Work Order ID 105872

Item Name: Aft Crosstube - High

DART AEROSPACE LTD		Work Order: 105872
Description: Crosstube High Aft (205/212)		Part Number: D212-664-201
Inspection Dwg: D212-664-241 Rev: D		Page 1 of 1

DRAWING NO. D212-664-241	TITLE CROSSTUBE ASSY (205/212 HI AFT)	REV. D	DART AEROSPACE LTD ENGINEERING ORDER		D.E.O. NO. D212-664-241-D-1	SHEET NO. SHEET 1 OF 2	SCALE NTS
DRAWN	CHECKED	MFG. APPR.	APPROVED	DE APPR.			
DATE 11.04.07	DATE 11.04.11	DATE 11.04.12	DATE 11/04/12	DATE 11.04.12

**D212-664-241-241B
ASSEMBLY DETAIL**

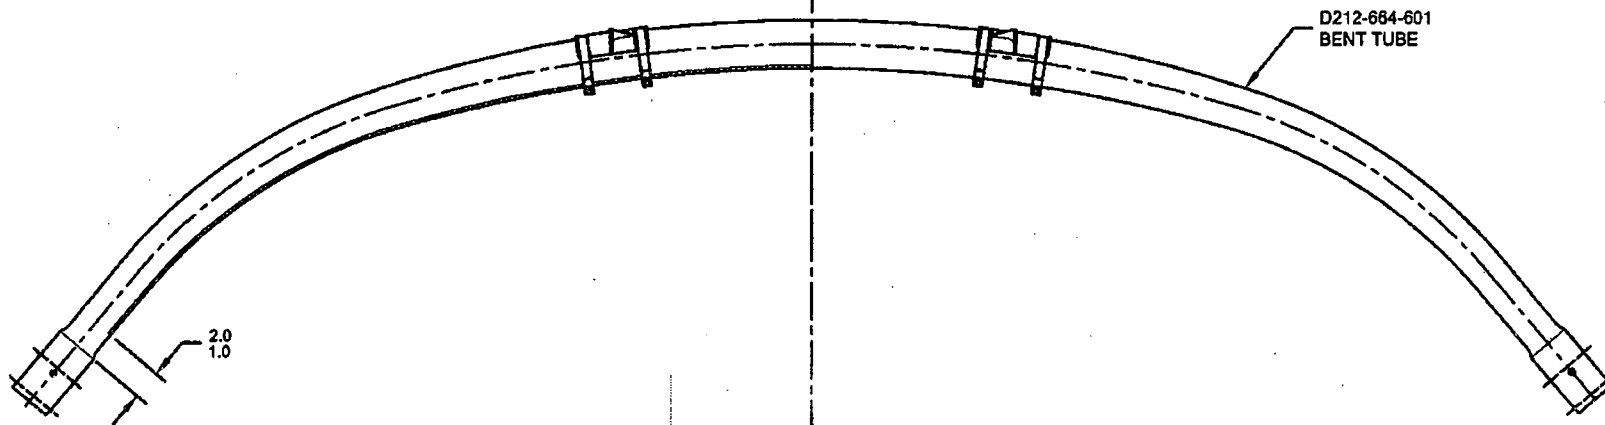
ADD AN INSPECTION WINDOW TO UNDERSIDE OF CROSSTUBE.

NOTES 2 OF SHEET 1 IS AMENDED AS FOLLOWS:

- 2) FINISH: CHEMICAL CONVERSION COAT PER DART QSI 005 4.1
PRIME INSIDE AND OUTSIDE PER DART QSI 005 4.2
MASK UNDERSIDE OF CROSSTUBE AS SHOWN (HATCHED AREA) AND
PAINT OUTSIDE PER DART QSI 005 4.2
REMOVE MASKING AND APPLY CLEAR COAT

MASK AREA PRIOR TO PAINTING,
REMOVE MASKING AFTER PAINT
AND APPLY CLEAR COAT
